Access Consulting  
 Building Compliance  
 Ref: AN019-213829 44-45 Tench Ave Jamisontown  
 Reviewed by: Lucy Alderson  
 Date: 11/12/2019

PROJECT  
 ORANGE FIELDS

CLIENT	MKT CAFE PTY LTD	SCALE	SHOWN@A2	JOB NO.	0461
ADDRESS	44-50 TENCH AVE JAMISONTOWN NSW	DATE	27.09.19	DRAWN	MW
DRAWING NAME	PROPOSED SITE PLAN	DRAWING NO.	02	ISSUE	D

1 DETAIL PLAN SCALE 1:100 @ A2

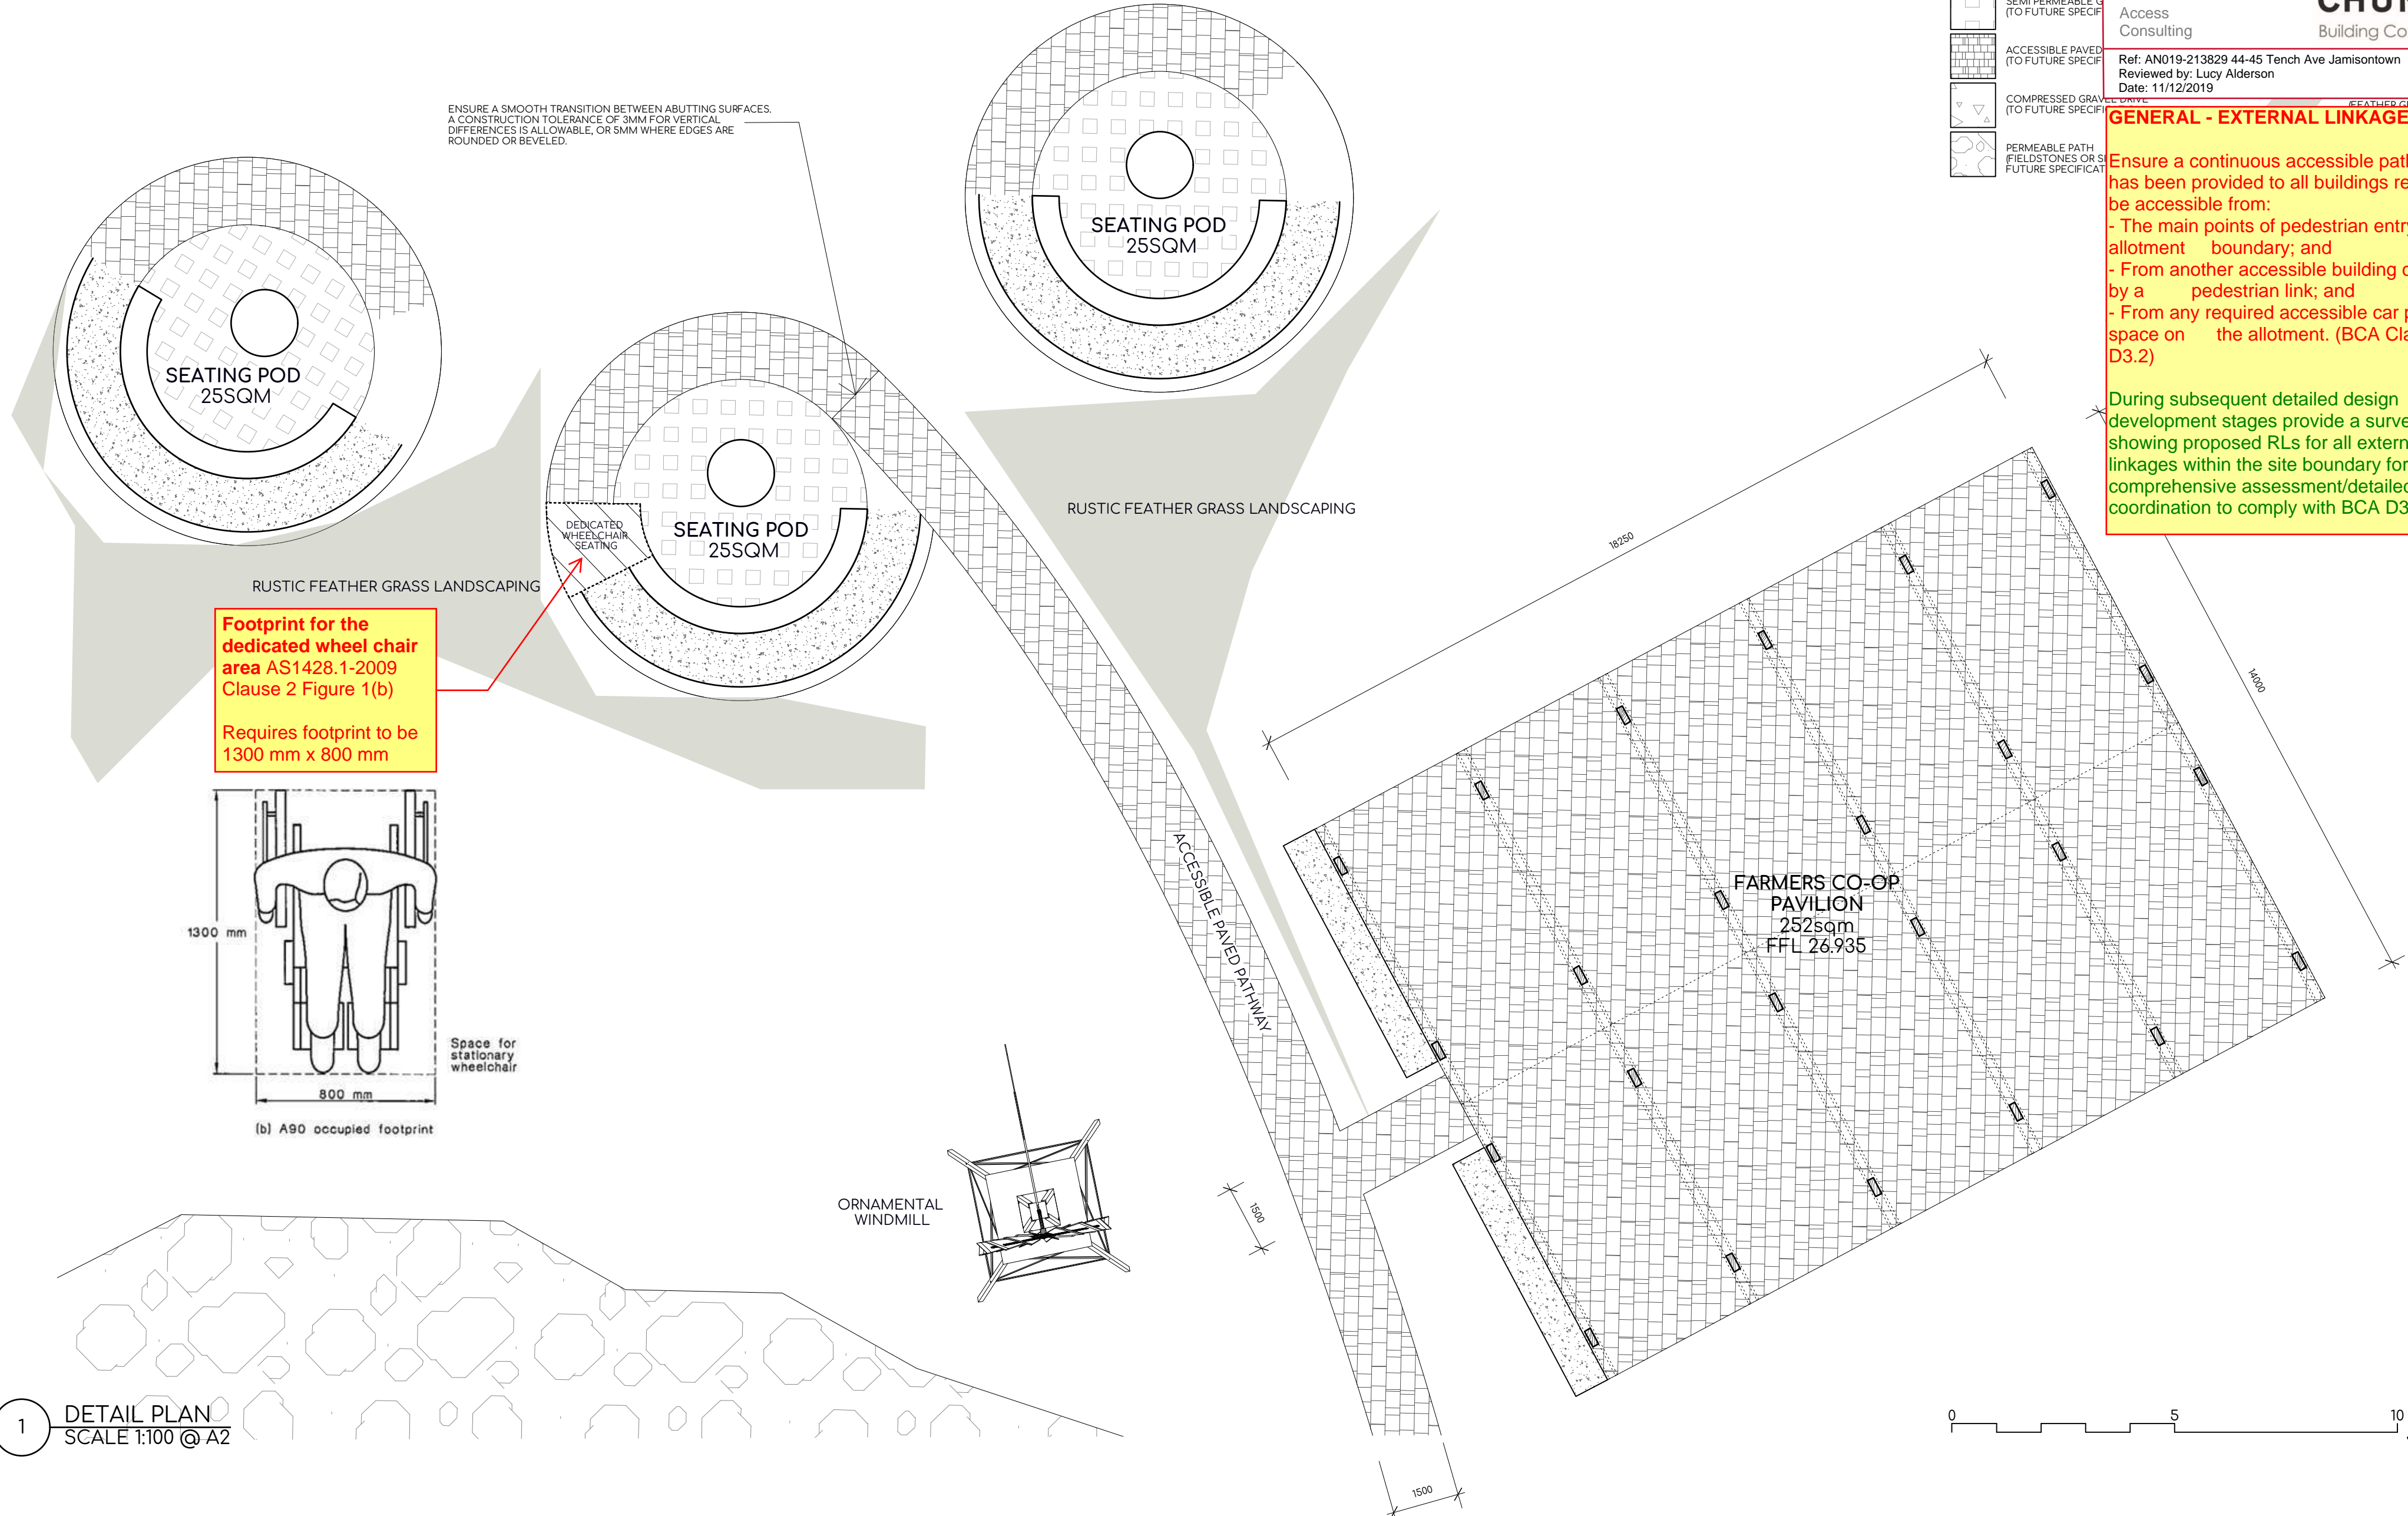
All curved pathways are required to be minimum 1500mm wide.  
- Can Comply

**Ambulant facilities - AS 1428.1 (2009) Clause 16.**  
Width of ambulant sanitary compartments appear too narrow. The finished internal width of the compartment shall be between 900mm and 920mm.  
**Note - The 900mm - 920mm circulation space is the site tolerance between the finished wall surface (width). If a skirting is installed which protrudes out beyond the finished wall surface, this too must provide the 900mm - 920mm circulation space. Both areas must have strict circulation space ranging between 900mm - 920mm.**  
- Can Comply

Set outs of sanitary fixtures and fittings required during subsequent detailed design development stages to comply with BCA D2.4.

**Accessible sanitary facilities - AS 1428.1 (2009), Clause 15.**  
Designers to ensure the accessible unisex sanitary facilities comply with AS 1428.1 2009, Clause 15 including circulation spaces, exclusion zones, fitting/fixture locations and signage.  
- Can Comply

Set outs of sanitary fixtures and fittings required during subsequent detailed design development stages to comply with BCA D2.4.

Ensure a continuous accessible path of travel has been provided to all buildings required to be accessible from:

- The main points of pedestrian entry at the allotment boundary; and
- From another accessible building connected by a pedestrian link; and
- From any required accessible car parking space on the allotment. (BCA Clause D3.2)

During subsequent detailed design development stages provide a survey showing proposed RLs for all external linkages within the site boundary for a comprehensive assessment/detailed coordination to comply with BCA D3.2.

Provide details of internal layout for assessment during subsequent detailed design development stages.  
- Can Comply

**Footprint for the dedicated wheel chair area AS1428.1-2009 Clause 2 Figure 1(b)**

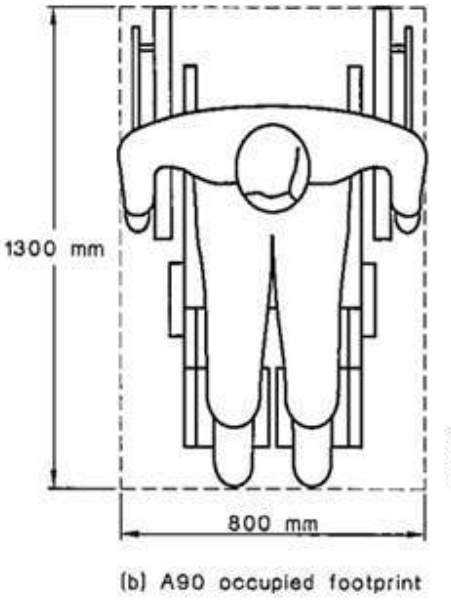
Requires footprint to be 1300 mm x 800 mm

1 DETAIL PLAN  
 SCALE 1:100 @ A2

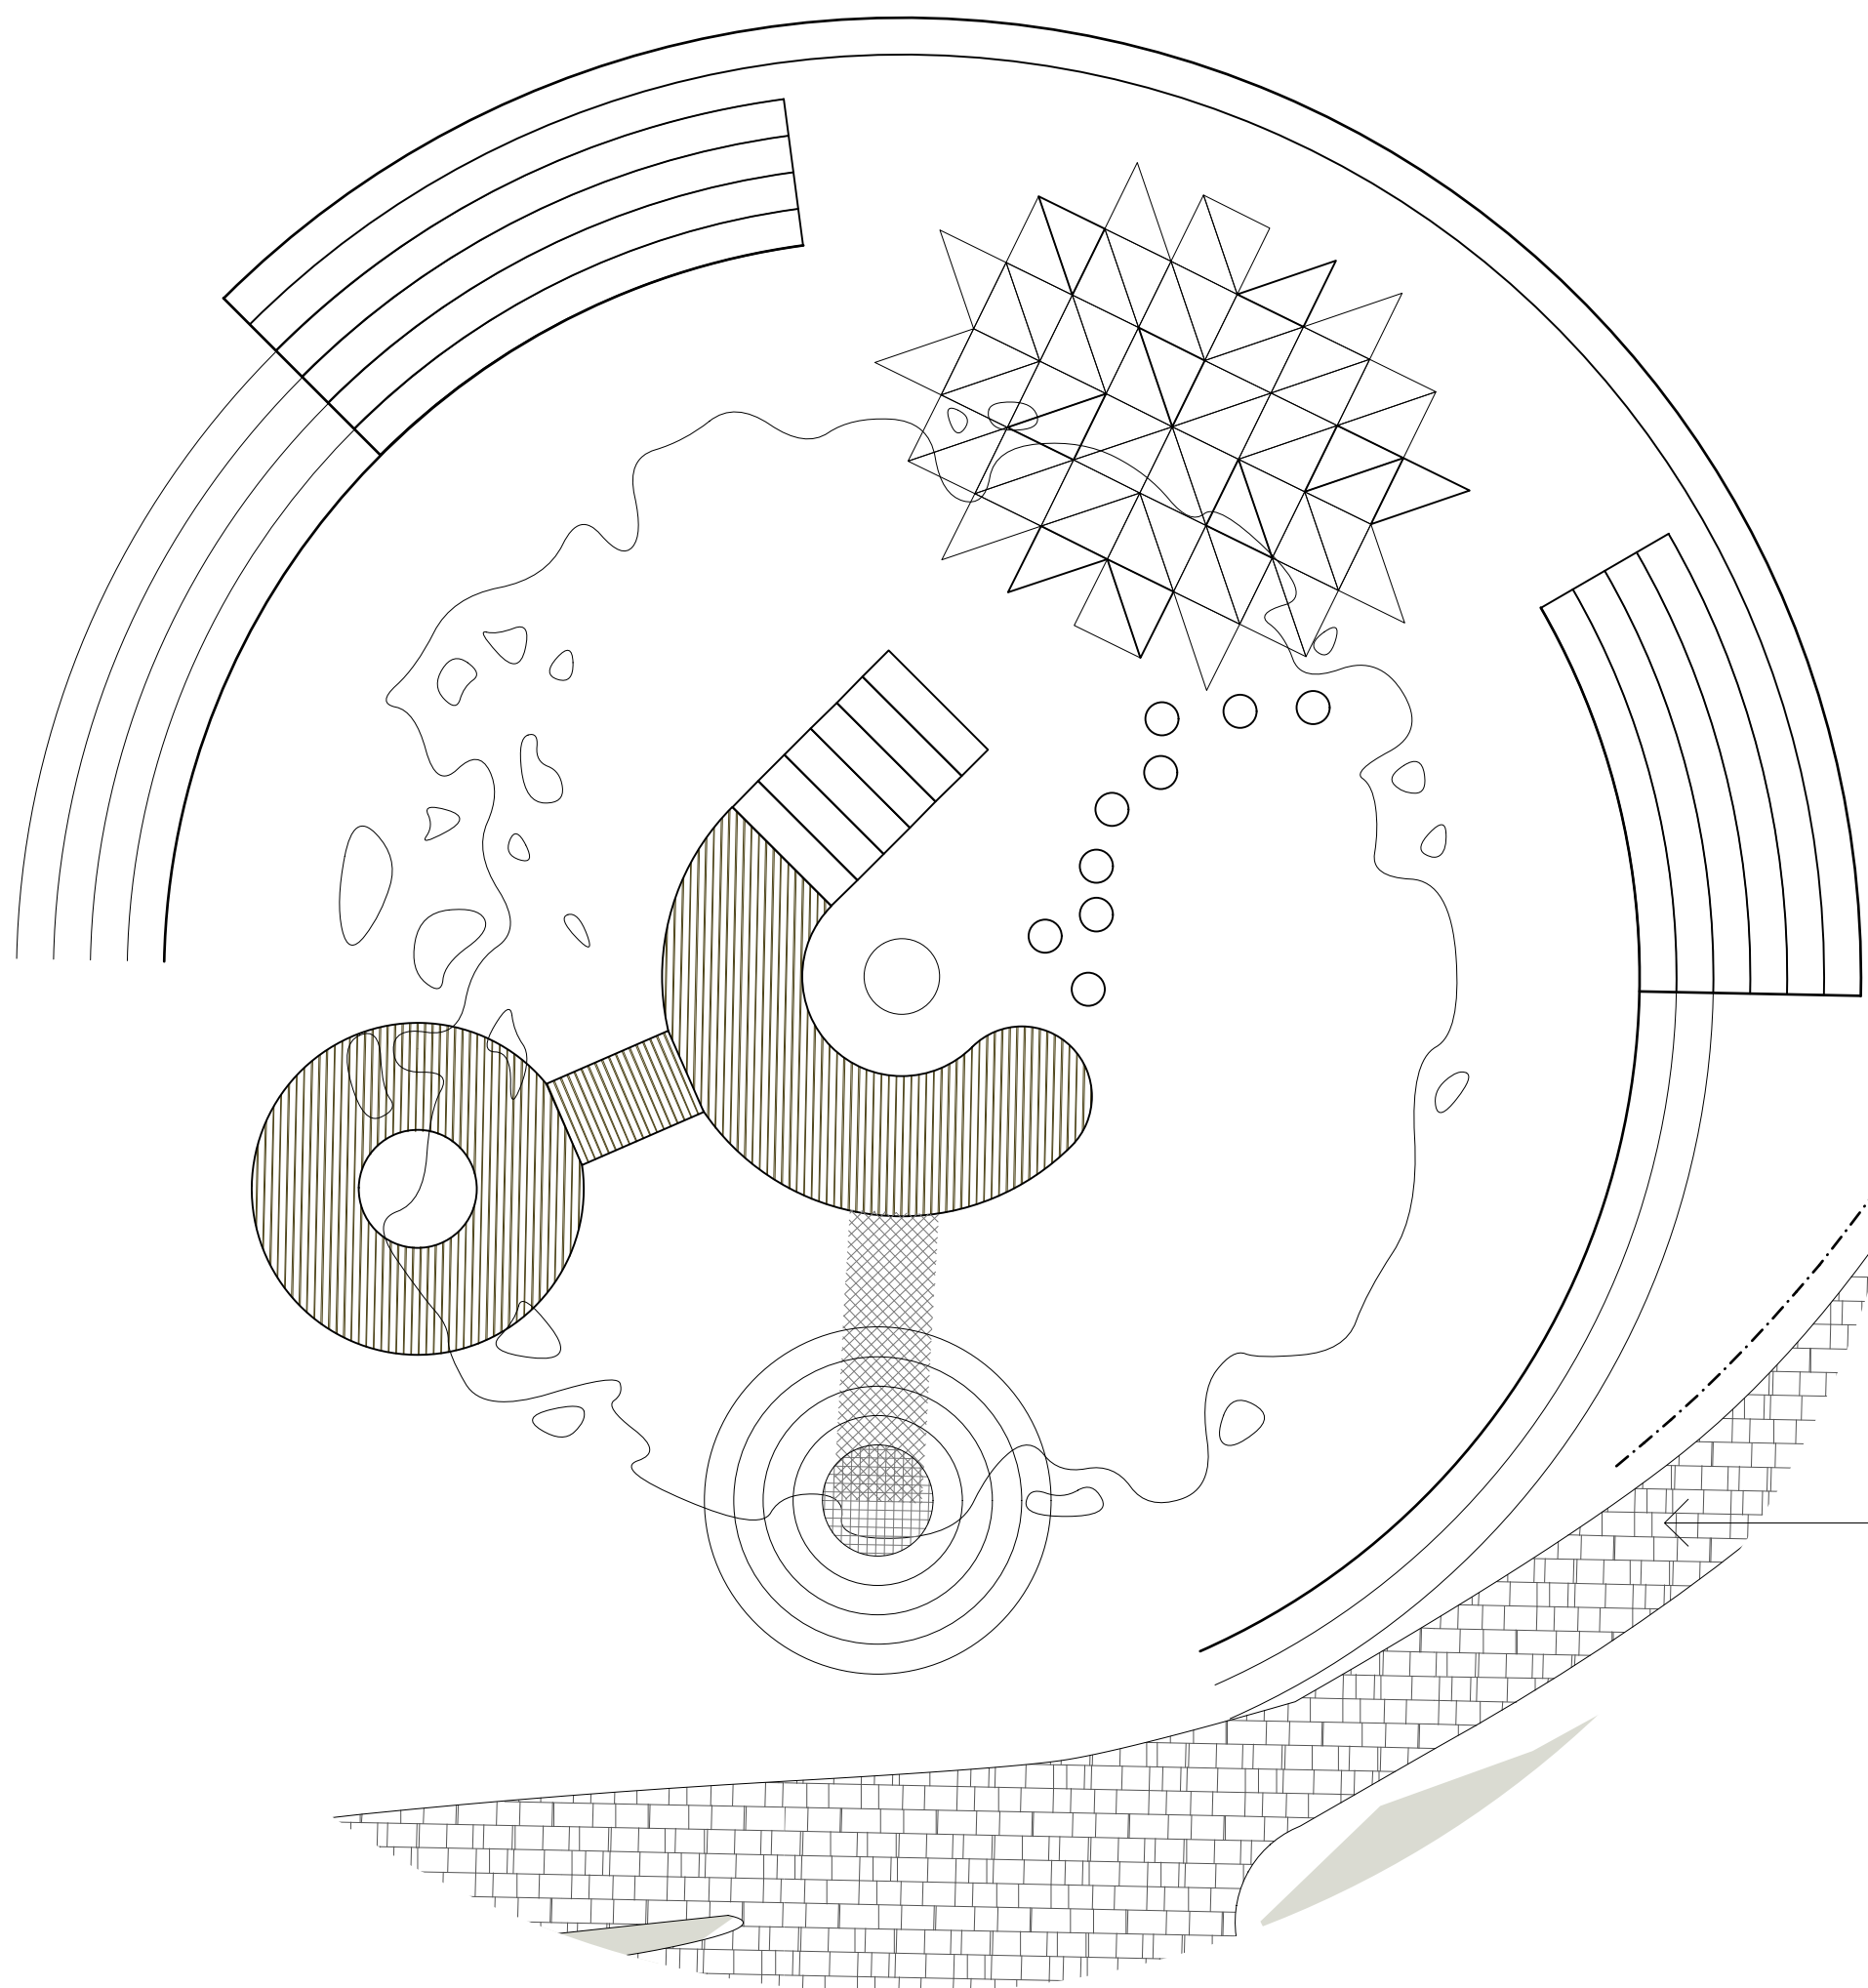
Ensure a continuous accessible path of travel has been provided to all buildings required to be accessible from:  
 - The main points of pedestrian entry at the allotment boundary; and  
 - From another accessible building connected by a pedestrian link; and  
 - From any required accessible car parking space on the allotment. (BCA Clause D3.2)

During subsequent detailed design development stages provide a survey showing proposed RLs for all external linkages within the site boundary for a comprehensive assessment/detailed coordination to comply with BCA D3.2.
